16 August 2016

# Re: Letter of Objection to State Significant Development 7421 for the Proposed Expansion of an Existing Waste Management Facility at 20 Hearne Street, Mortdale.

Figure 1: Existing driveway from Hearne Street (Source: SIX Maps)

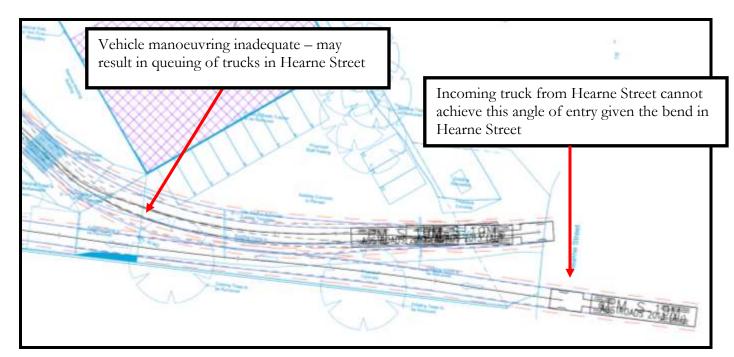
Vehicle access to the site is currently from Hearne Street as a two-way crossover driveway approximately 6 metres wide, illustrated in **Figure 1**. This is considered to be totally insufficient to accommodate the anticipated truck movements through the site on a 24 hour basis.

While the Traffic Report indicates that there is a proposed 16.5 metre wide single two-way driveway to be provided, it is unclear how such a wide driveway can be accommodated on this site given the narrow frontage the site has to Hearne Street. The proposed driveway is considered to be inadequately shown on the plans and it is doubtful that such a driveway can be provided to Hearne Street.

Figure 3: Proposed Site Layout (Source: Insight Architecture, 21 March 2016)

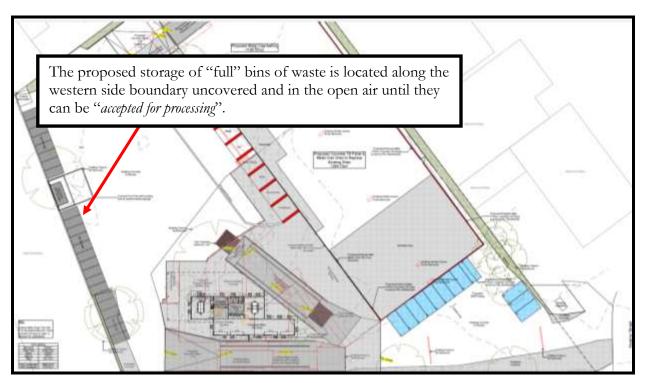
The operation of the premises as outlined above is concerning in that there will be bins full of waste being stored outside and while it is proposed to cover these bins, in practice this is unlikely to be undertaken. Such a condition would require significant compliance action which is unlikely to be undertaken.

The placement of bins full of waste to be stored outside until "accepted for processing" results in full bins sitting outside for an unlimited time period which has significant potential to result in dust and other air pollution affecting adjoining and nearby properties. This is illustrated in **Figure 3**.

Figure 4: Proposed new shed (perspective) (Source: Insight Architecture, 21 March 2016)

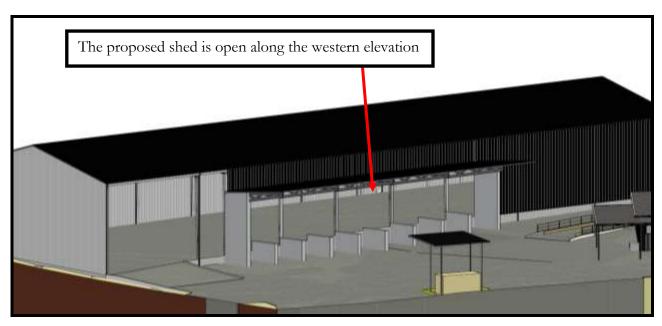
Furthermore, the proposed "shed" is not fully enclosed and the bins full of sorted waste along the western edge of the shed are being housed under an awning and not within the building. The sorting of the waste is to occur within the shed however, with the sides of the building being open, there is likely to be significant dust and other air borne particles emanating from the building.

The most effective way to minimise dust and another air pollution from adversely affecting the surrounding area is for the undertaking of the sorting, separating and storage activities to be undertaken inside a building with roller doors and the like closed. Notwithstanding the dust suppression measures proposed, the proposed open-form shed, the method of sorting and the storage of sorted waste bins outside in an open form shed is unacceptable and is likely to result in dust and air pollution to surrounding properties. This is illustrated in **Figure 4**.
